13 November 2024

**RE: SECTION 4.55(2) MODIFICATION APPLICATION TO DA/2019/653:
119 MCFARLANES ROAD CHISHOLM (LOT 1 DP 198776)
ONE INTO 143 LOT RESIDENTIAL SUBDIVISION AND ASSOCIATED INFRASTRUCTURE**

Figure 1: Eastern boundary of approved subdivision layout plan.

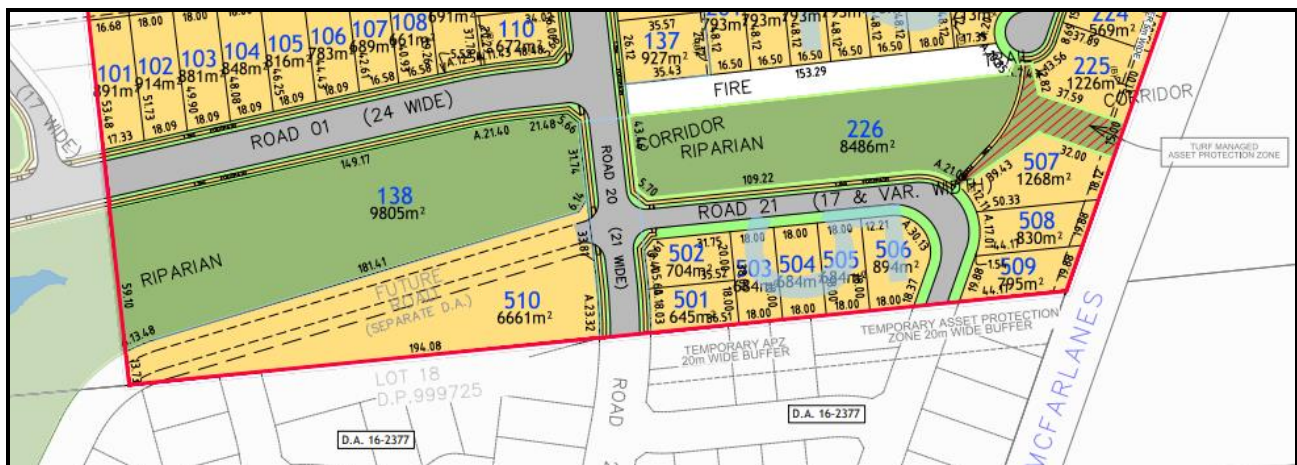
Approved Lot 510 on the eastern side was previously approved as part of a residue lot – refer **Figure 1** below. The remainder of the residue lot was approved under adjoining DA 16/2377. As part of this modification, it is proposed to include the entire residue lot within the area of DA/2019/653 which now includes 6 residential lots (the land for all of which has been cleared and regraded under their existing consents) – refer **Figure 2** below.

Figure 2: Eastern boundary of proposed subdivision layout plan.

Figure 4: Proposed amendments for adjoining DA/2019/652:2.

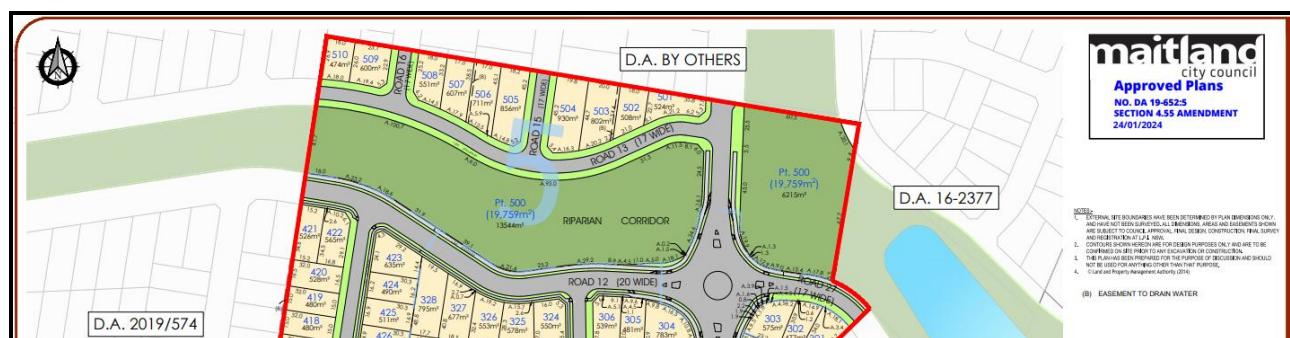
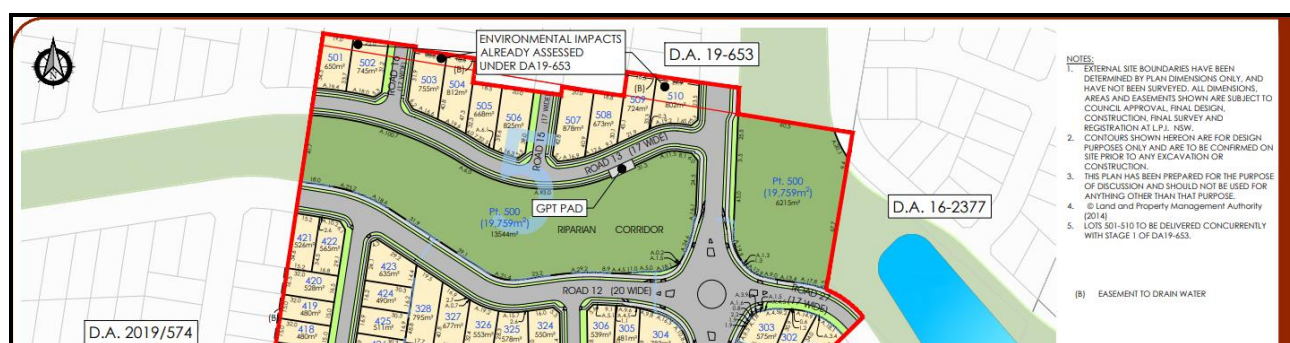
In relation to the amended southern boundary a separate Section 4.55 (1A) application has been lodged with Council to modify development consent DA/2019/652:2 granted on 28 April 2020 for a 132 lot Torrens title subdivision at 581 Raymond Terrace Road Chisholm (Lot 2 DP 1284512, formerly Lot 1 DP 1032753) to the south to address adjustments to the approved lot layout to ensure that lots in Stage 5 of that approval are of a suitable size and configuration to accommodate a building envelope for future residences - refer **Figures 3 and 4** below.

Figure 5A – Road 01 long section – in conflict with Condition 47 at limit of works.

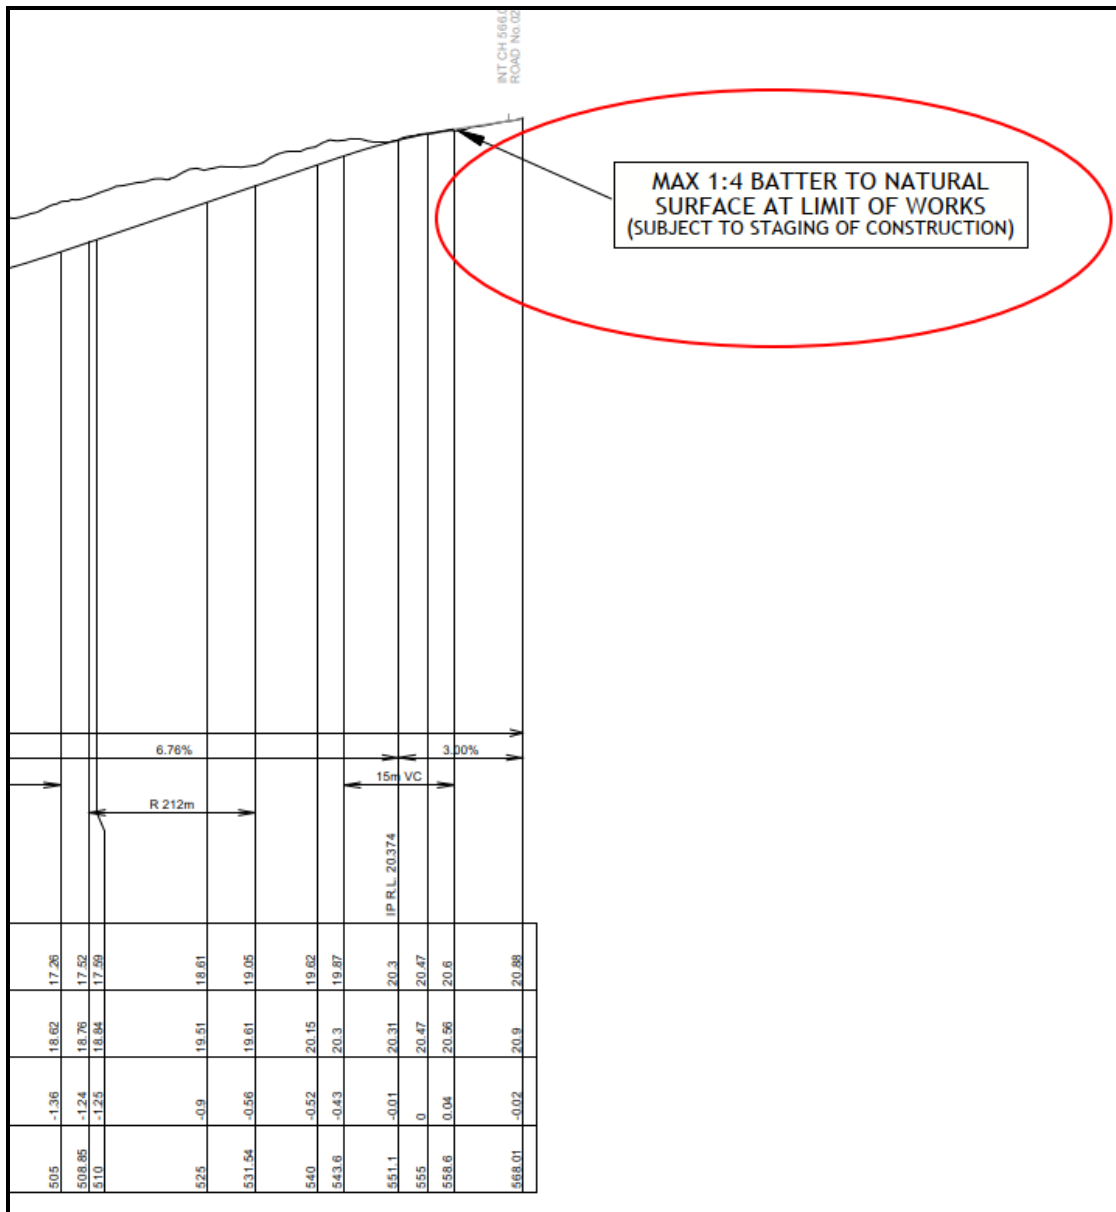
This consent condition is in conflict with the approved plans for this development and adjoining developments to the east, south and west, where design levels do not meet at natural surface levels at the boundary. This is evident on the long sections of Road 01, Road 02, Road 15, Road 16, Road 20 and Road 21. Please refer **Figures 5A-F** below.

47. *Prior to the issue of a Subdivision Works Certificate, the limits of all roads that meet adjacent property boundaries shall be designed so that the finished level at the centreline is at natural surface level, unless owner's consent is provided by the adjoining development site."*
